COLLINS SUBDIVISION, FIRST ADDITION

APPLICATION NUMBER 11 DATE April 1, 2004

REQUEST Subdivision

DETAIL SITE PLAN

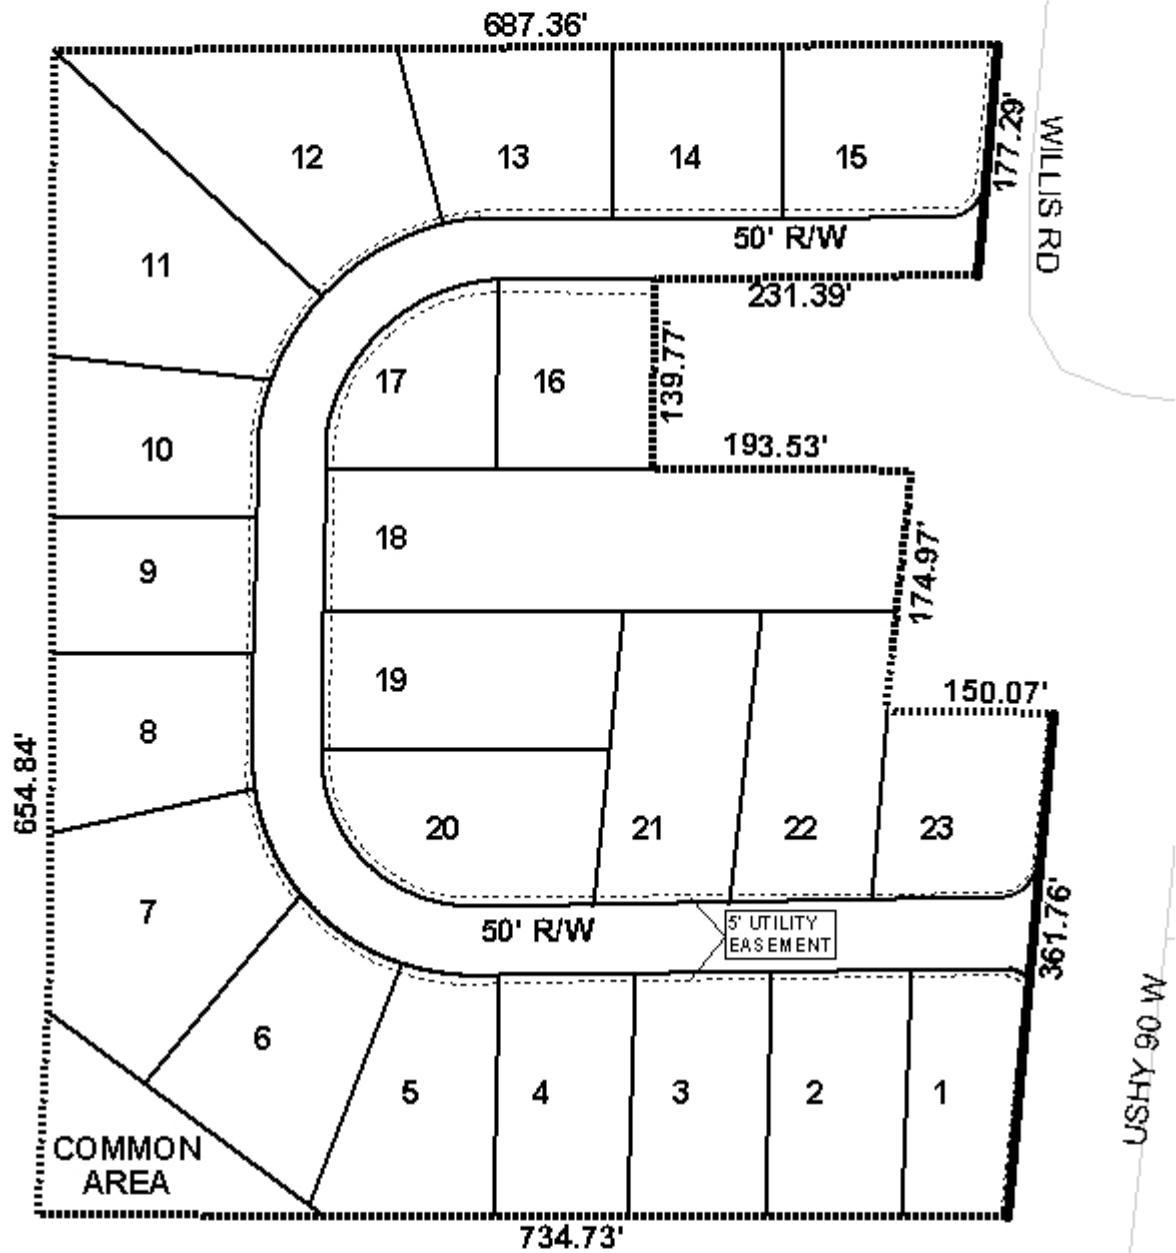
US Highway 90, which has a variable right-of-way, is shown as a major street on the Major Street Plan, and as such requires a 250-foot right-of-way; therefore, the dedication of sufficient right-of-way to provide 125-feet from the centerline should be required.

As proposed, Lots 1 and 23 would have frontage along US Highway 90 and the new street, and Lot 15 would front Willis Road and the new street. In order to provide proper access management, the placement of a note on the final plat stating the Lots 1, 15 and 23 are denied direct access to US Highway 90 and Willis Road, should be required.

The detention area is labeled as common area; thus a note labeling this area as a detention area and stating that the maintenance thereof is the responsibility of the property owners, should be required on the final plat.

As proposed, Lot 18 would exceed the width to depth ratio; therefore a waiver of Section V.D.3 would be required.

The 25-foot minimum building setback line is not shown but would be required on the final plat.

With a waiver of Section V.D.3., the plat will meet the minimum requirements of the Subdivision Regulations and is recommended for Tentative Approval subject to the following conditions: 1) the dedication of sufficient right-of-way to provide 125-feet from the centerline of US Highway 90; 2) the placement of a note on the final plat stating the Lots 1, 15 and 23 are denied direct access to US Highway 90 and Willis Road; 3) the placement of notes on the final plat labeling the common area and stating that the maintenance of the common area is the responsibility of the property owners; 4) the placement of a note on the final plat stating any lots which are developed commercially, and adjoin residentially developed property must provide a buffer, in compliance with Section V.A.7. of the Subdivision Regulations; and 5) the placement of the 25-foot minimum building setback line on the final plat.
